CHEMETRON CORPORATION

Subject: Revised RESRAD Analysis for the Bert Avenue Site per NRC Comments
(Telecon with NRC and B. Koh Personnel dated August 16, 1996)

**Revised RESRAD Analysis
Bert Avenue Site**

FIGURE 1

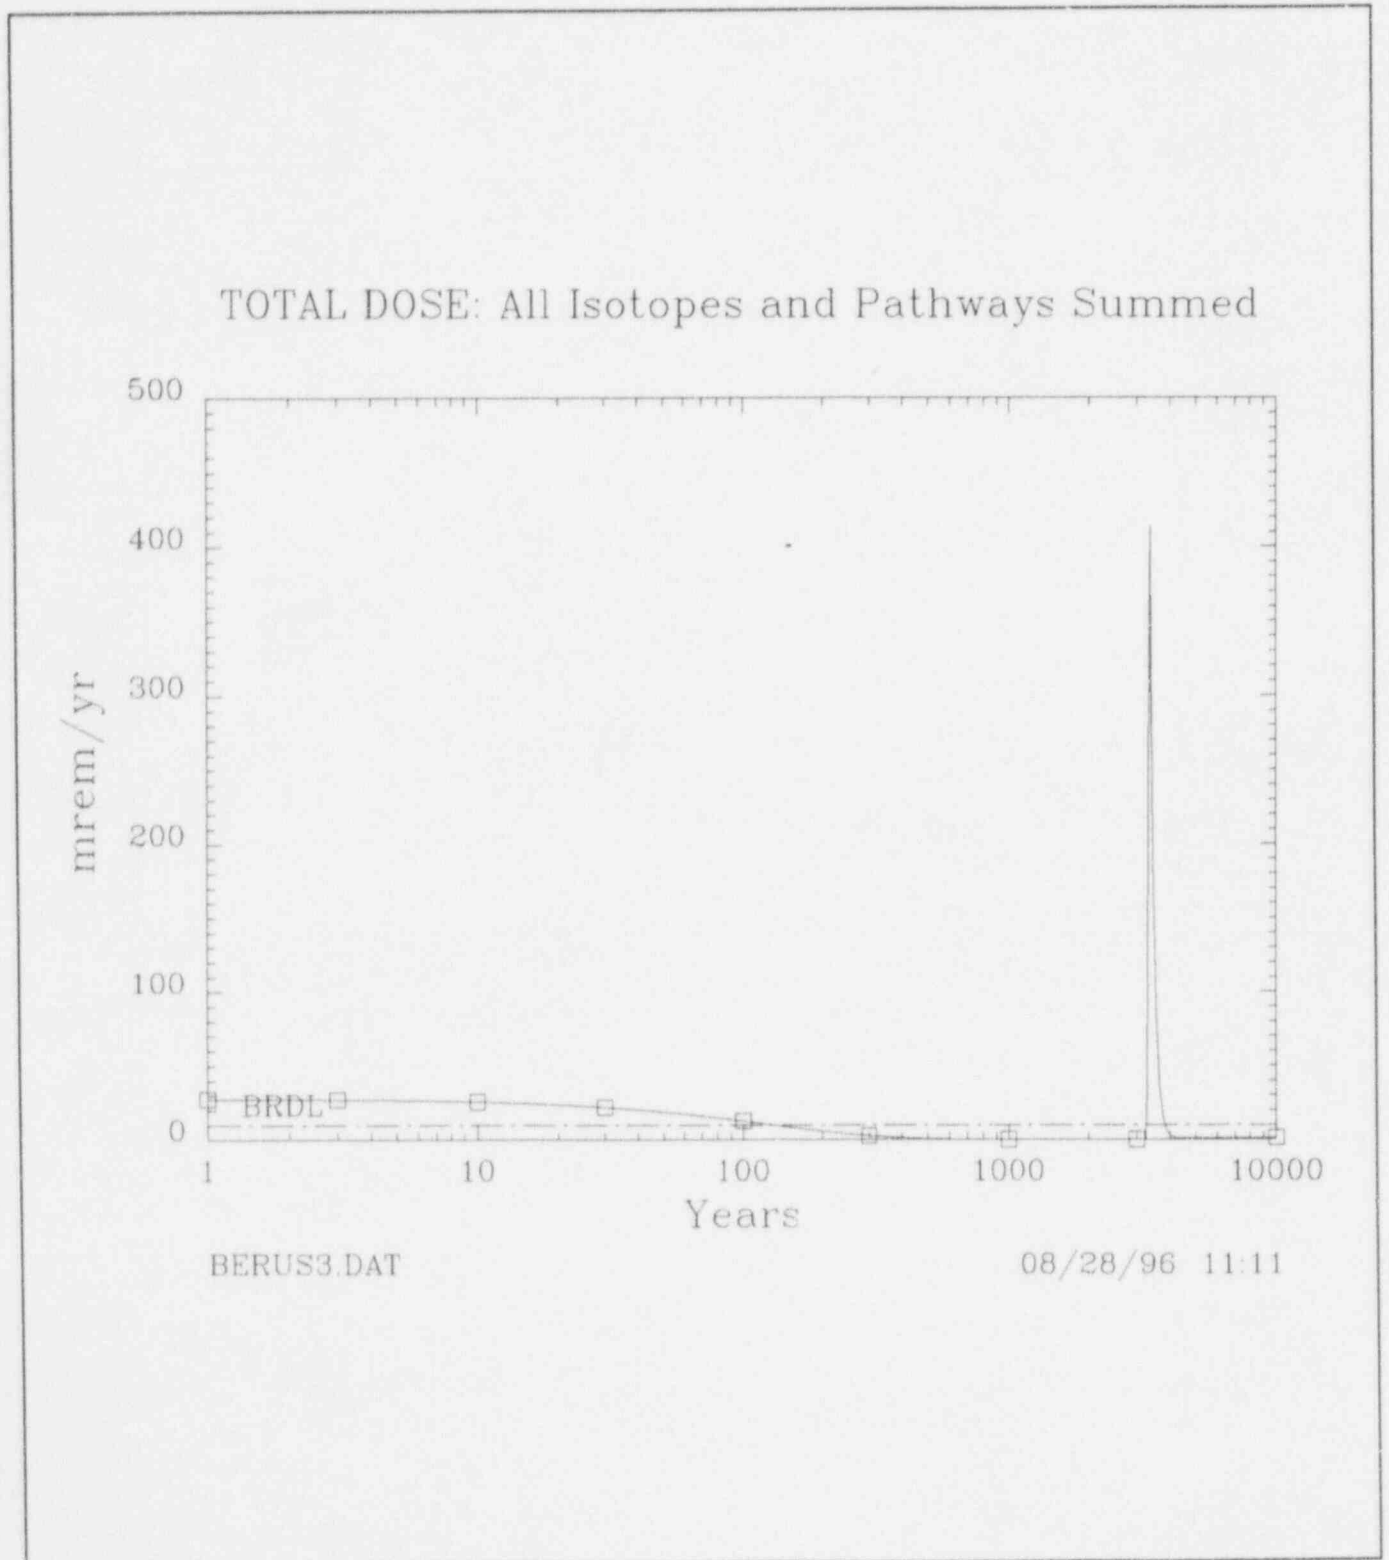
This letter is in response to NRC comments on the RESRAD analysis submitted June 21, 1996. The comments were given to B. Koh and Associates, Inc. in a telephone conference on August 21, 1996. Based on a review of the previously submitted RESRAD analysis, NRC personnel determined that a change in the RESRAD "Graphics Parameters" had an impact on the calculated dose from the groundwater pathway.

In order to address the NRC concern, the RESRAD analysis was rerun and the graphics points per curve parameter was increased from 32 points to its maximum, 1,024 points. Also, NRC and B. Koh and Associates, Inc. personnel agreed that the addition of a third unsaturated zone to the analysis model would be more appropriate for modeling the assumed well depth of 140 meters.

As a result of changing the graphic points per curve from 32 to 1,024, as seen by comparing Figures 1 and 2, that the time for the peak dose from the groundwater pathway has shifted from approximately 5,500 years to approximately 3,400 years. The peak dose increased from approximately 4 mrem at 5,500 years to approximately 425 mrem at 3,400 years. The addition of the third unsaturated zone had no significant impact on the dose calculation.

The revised analysis resulted in a shifting of the time for the calculated peak dose from the groundwater pathway from approximately 5,500 years to approximately 3,400 years and the corresponding dose increased from approximately 4 mrem to approximately 425 mrem. In the RESRAD code, the magnitude of the dose and time dependence of the annual dose incurred by members of the farm family from the groundwater pathway is controlled by the rate at which

In conclusion, Chemetron believes that the calculated dose presented in Figure 1 is a result of an artifact in the RESRAD code. The calculated dose of Figure 2 was based on conservative assumptions and shows the maximum dose to be 27 mrem/year which occurs 1 year after the decommissioning is complete.
